Bulletin # 063

Pulley

Parts information

- Subject** The 71460069 pulley is being replaced with a new pulley
- Units Affected:** Stander 42" – serial 26288 through 35903
Sentar 52" & 61" – serial 26988 through 35988
Z 52" & 61" – serial 30200 through 36009

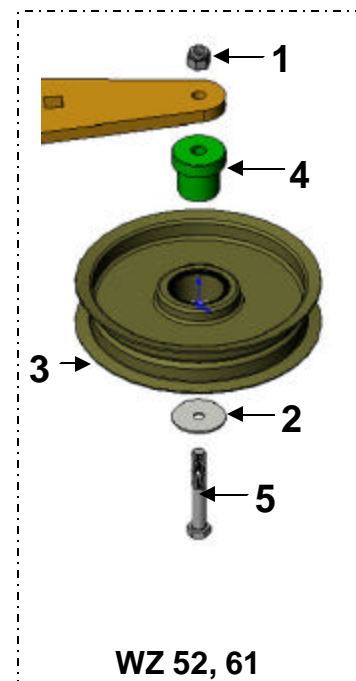
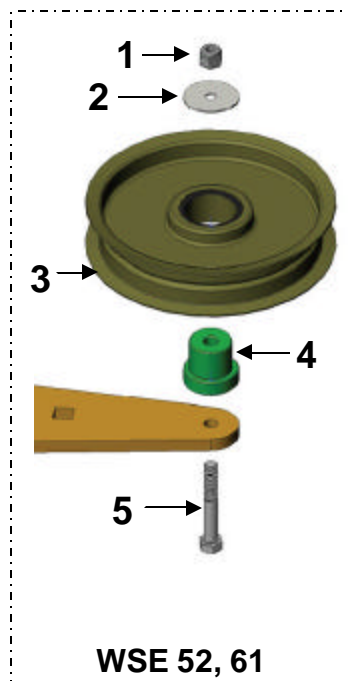
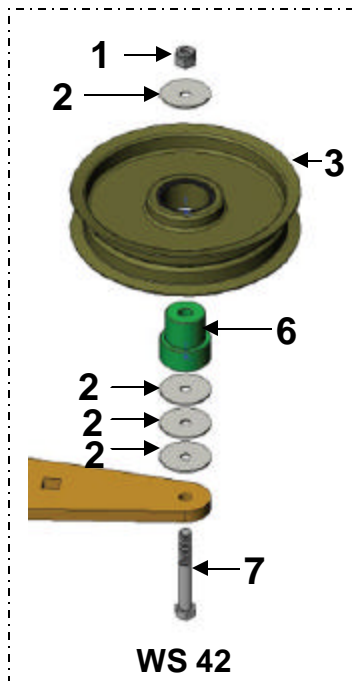
- Situation:** Pulley 71460069 is being replaced with part number 71460098. 71460098 requires a bore adapter and additional hardware for proper installation, fit and function

- Part number 71460069 is being superseded by kit part number 71460106 (for Sentar and Z applications). When an order is received for 71460069, it will be filled with 71460106. 71460106 is a kit that includes:

- 71460098 – pulley
 - 22420007 – bore adapter for certain Sentar and Z mowers
 - 13990038 - washer
- ➔ If replacing the pulley on a 42" Stander, see below for individual component part numbers – a pulley kit is not available for this mower

1		Nut, 3/8 – 16	12990031
2	*	Washer, Flat 3/8x1-1/2	13990038
3	*	Idler Pulley 6"	71460098
4	*	Bore Adaptor WSE, WZ	22420007
5		Bolt, 3/8 – 16 x 2-1/4	11990068
6	*	Bore Adaptor WS 42	22420006
7	*	Bolt, 3/8 – 16 x 2-3/4	11990006

Items with an asterisk (*) are required for the initial upgrade to the 71460098 pulley.
